From: Steven Fairchild, HP (steve.fairchild@hp.com)
 Date: 7 December 2004
 Subject: SAS 1.1 External Connector Interoperability

To resolve this interoperability issue, HP would propose the following text (in blue) be incorporated in SAS 1.1 clause 5.2.3;

Figure 1, Plugfest Configuration

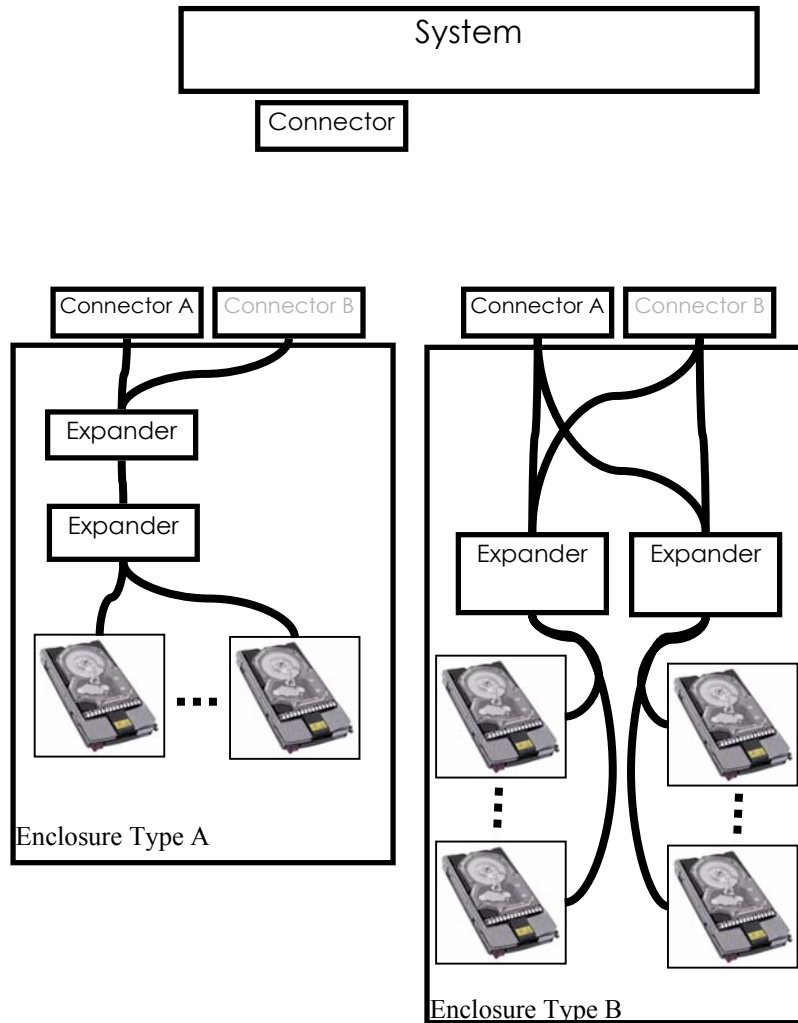
The first issue is an incompatibility that is created when phys routed to an external connector are attached to different expander and/or end devices within the enclosure (see Figure 1).

When the System connector was attached to either of the enclosures (from different manufacturers) the devices were properly discovered. Both enclosures were designed to be “daisy chained” to additional enclosures. When enclosures from the same manufacturer were

“daisy chained” (Enclosure type A to Enclosure type A or Enclosure type B to Enclosure type B) the topology was properly discovered. However when enclosures were “daisy chained” to each other (Enclosure Type A to Enclosure Type B or Enclosure Type B to Enclosure Type A) the topology was not properly discovered.

For “daisy chaining” to function, both enclosures defined one connector (assume Connector A for both enclosures) to use Table routing for the phys in the connector and one connector (assume Connector B for both enclosures) to use Subtractive routing for the phys in the connector. This allows the normal SAS routing behavior of chaining Table to Subtractive to create a large expander device set.

Enclosure Type A chose to attach all of the phys within each of its connectors to a single expander. Enclosure Type B chose to attach the phys within each of its connectors to multiple expanders. These two design choices are what caused the interoperability problem. When Enclosure Type A, Connector B is attached to Enclosure Type B, Connector A (Subtractive phys of Enclosure A to Table phys of Enclosure B) a conflict occurs because the expander attached to Enclosure Type A, Connector B has to different SAS Addresses attached to its Subtractive phys. This is an illegal routing configuration, because the expander attached to Enclosure Type A, Connector B cannot determine where to route its Subtractive addresses. Similar routing issues result from the different connection combinations (see Table 1).

From Table 1, the only legal connection Enclosure A, Connector A attached to Enclosure B, connector B had a problem due to a design decision based on the assumption that a connector would only present a single SAS address if it was attached to an expander.

5.2.3.x SAS external receptacle connector restrictions

SAS devices using the external receptacle connector shall be attached to only one device type (i.e. end device type, edge expander device or fanout device).

SAS devices using the external receptacle connector attached to expanders shall be constrained to the following;

- a) An external receptacle connector shall be attached to only one expander device type (i.e. edge expander device, or fanout expander device), and
- b) An external receptacle connector shall be attached to only one expander device.
 - a. The expander phys contained within the external receptacle connector shall define a single port (ie. single SAS address),
 - b. The expander phys contained within the external receptacle connector shall have the same routing attribute (i.e. subtractive or table, but not both), and
 - c. The expander phys contained within the external receptacle connector that use the table routing attribute shall have the same number of route table entries.

SAS devices using the external receptacle connector may be attached to one or more end devices.

Figure L. 1, SAS Icon for Cables and End Devices

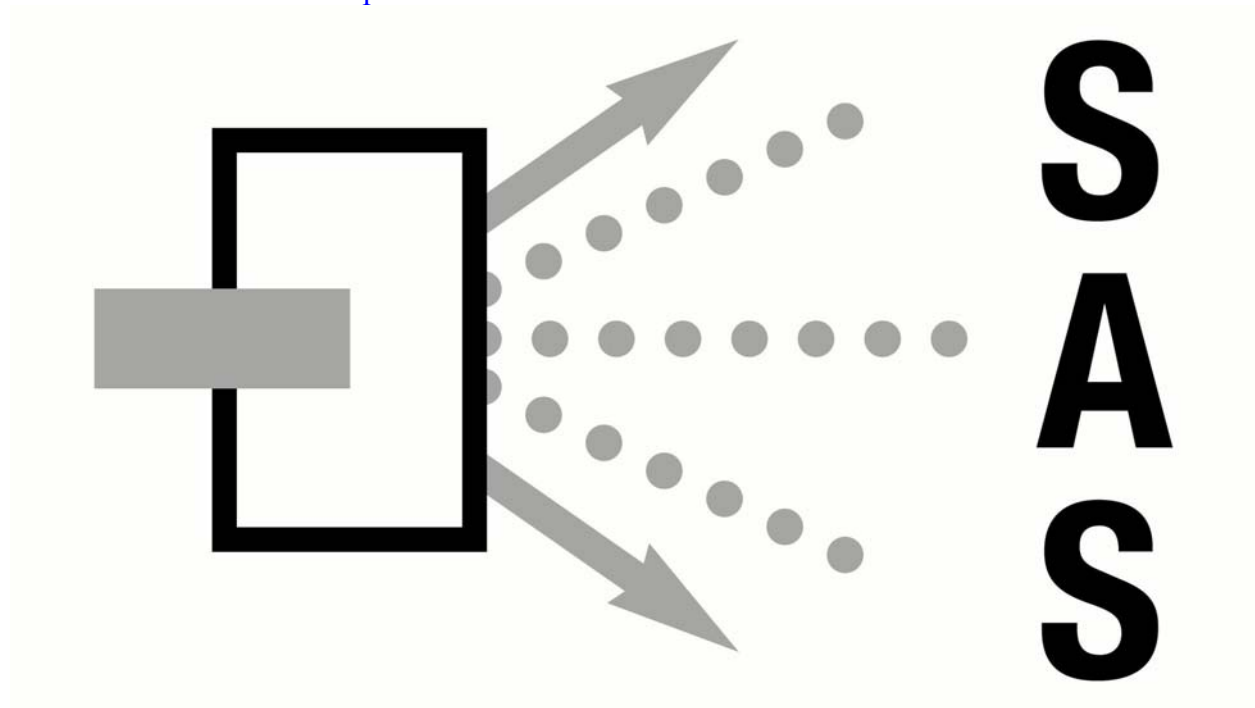
The second issue is a usability issue that occurs because it is difficult to describe how external connectors may be legally connected.

Using Figure 1 to illustrate the problem. During the plugfest there was no standardized way to reference Connector A and Connector B of each Enclosure. There was also no set of guidelines that described connectivity capabilities of an enclosure.

The remainder of this proposal recommends that a naming convention be provided for external connectors (including a set of icons) that provide guidelines for connectivity.

The SAS icons are shown in figure L1 to L3. One of these icons should be included on all connections to devices compliant with this standard.
